H. Chaffinow Homes Inc CO, Falcon - CUH003020 - PM at Bent Grass FUSION2-Plant/ECQ/H20 P 04.0 Cover Sheet/Draw - Bent Bridge - 12/4/2022

EARLY GRADING & EROSION CONTROL PLANS
FALCON MEADOWS AT BENT GRASS FILING NO. 3
FOR
CHALLENGER COMMUNITIES, LLC

EROSION CONTROL
DETAILS

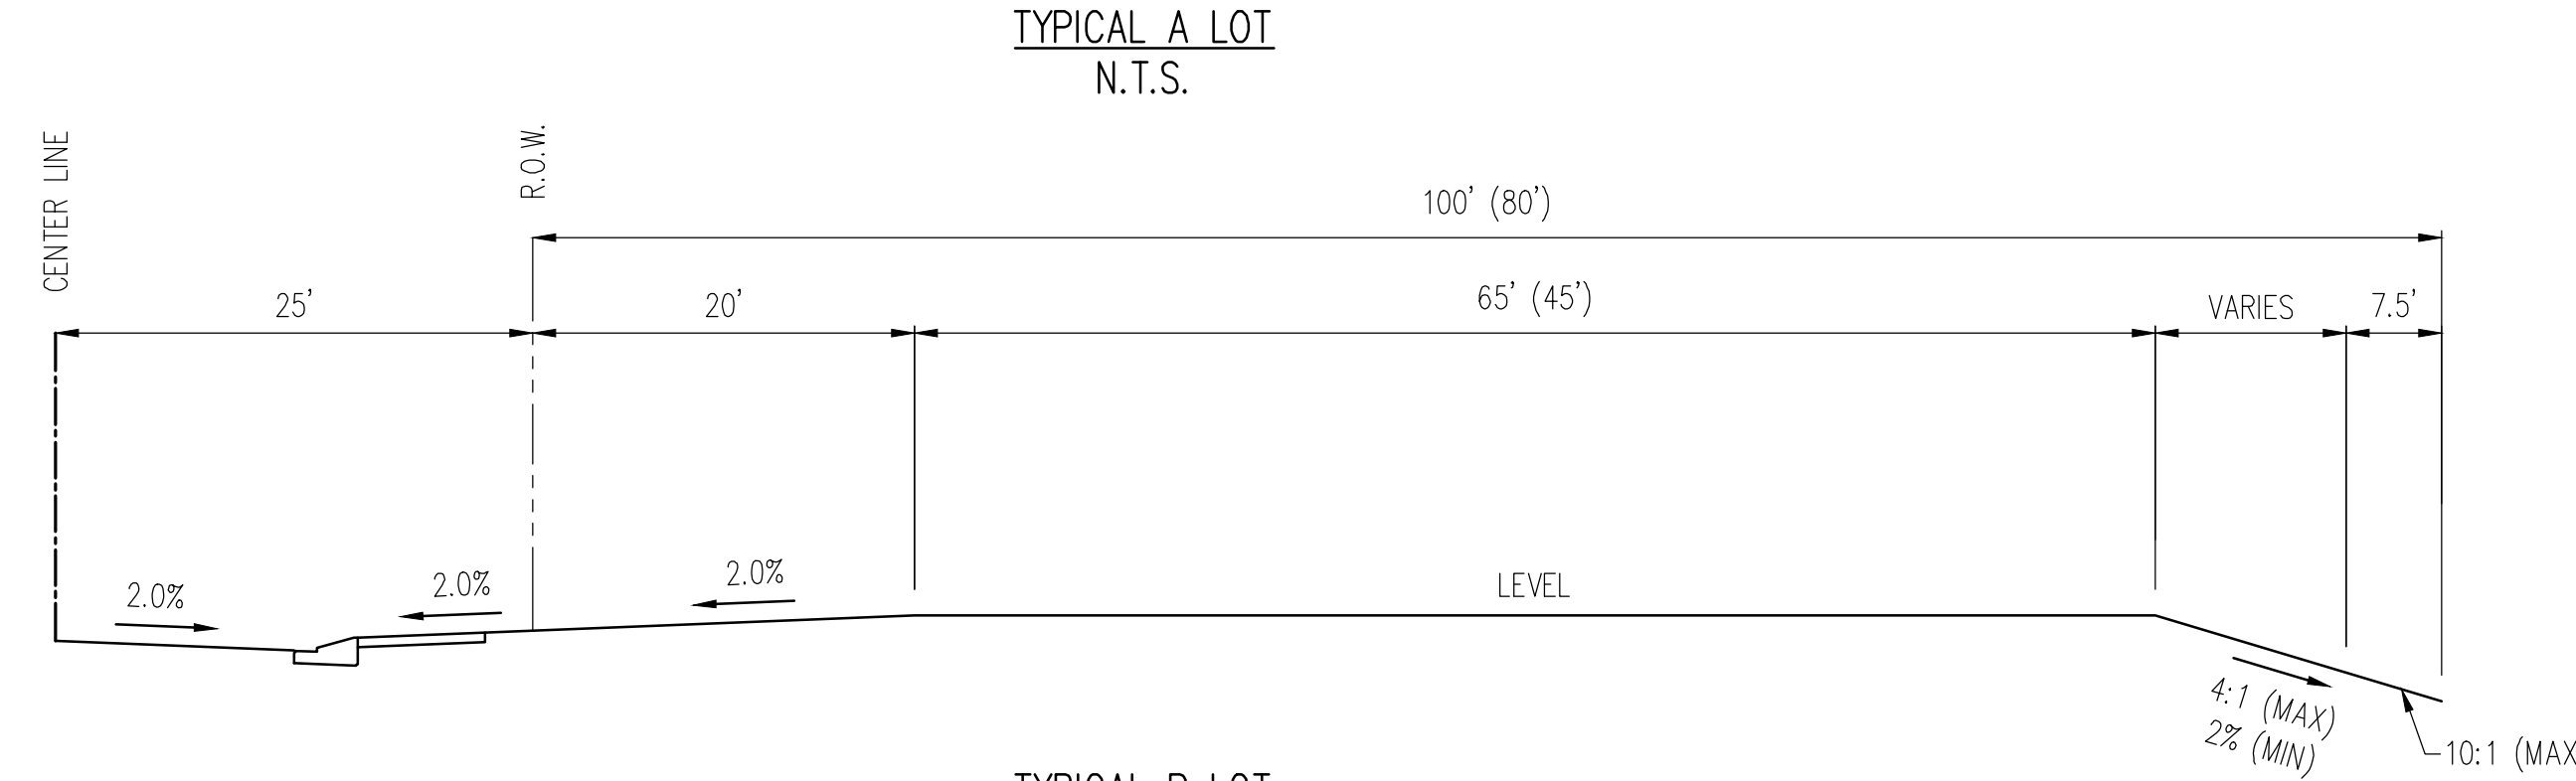
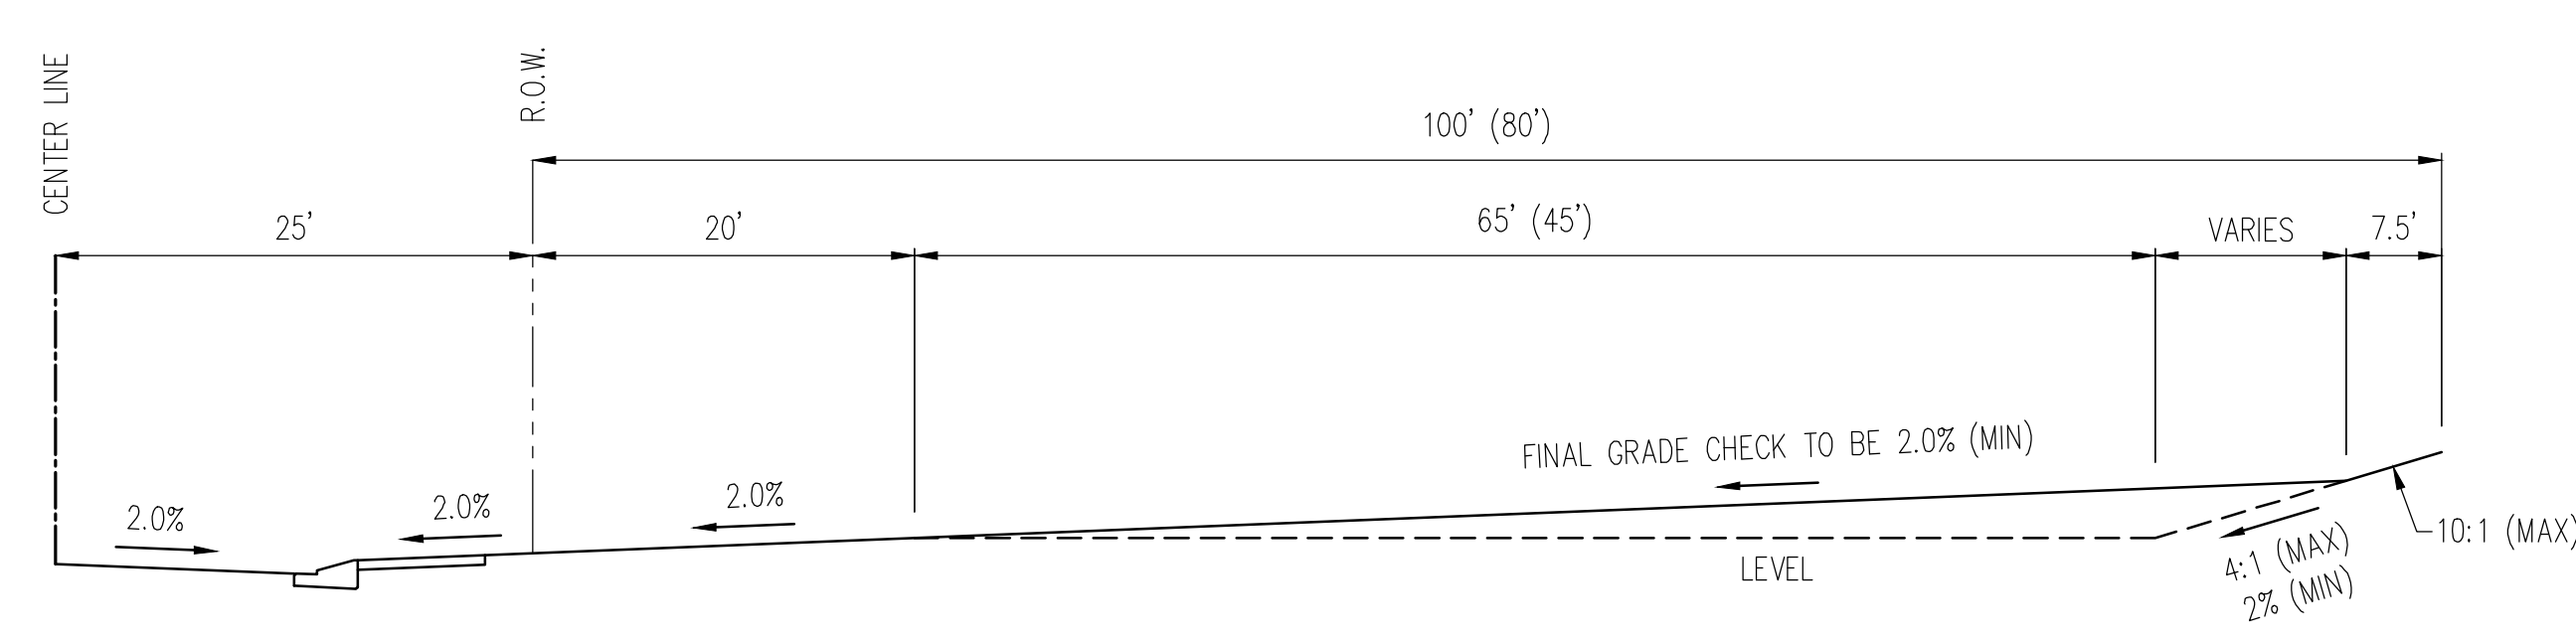
Provide cross section label for the proposed swale D

Alot of the runoff from the proposed development on this sheet (about 2-3 acres) is tributary to this point. Per pg 24 of the SWMP text, all flows from F3 will be conveyed to the existing North and South ponds.

I am concerned about the subsequent mess of sediment between this point and the South Pond. The runoff has to travel a long way along the road and/or storm drains to get to the pond, which will mean sediment deposits throughout the C&G and UG pipes. And the only protection upstream is 3 straw bales and 3 rock socks. Consider the need for onsite TSB(s) and/or sediment traps.

This is a typical comment for the previous sheet as well (except the areas are different sizes and are trib to the North Pond).

CROSS SECTION LABEL IS PRESENT

SEDIMENT TRAPS AND CONSTRUCTION FENCE PLACED IN SWALE FLOW LINES AND VTC REDUCED TO 20' WIDTH
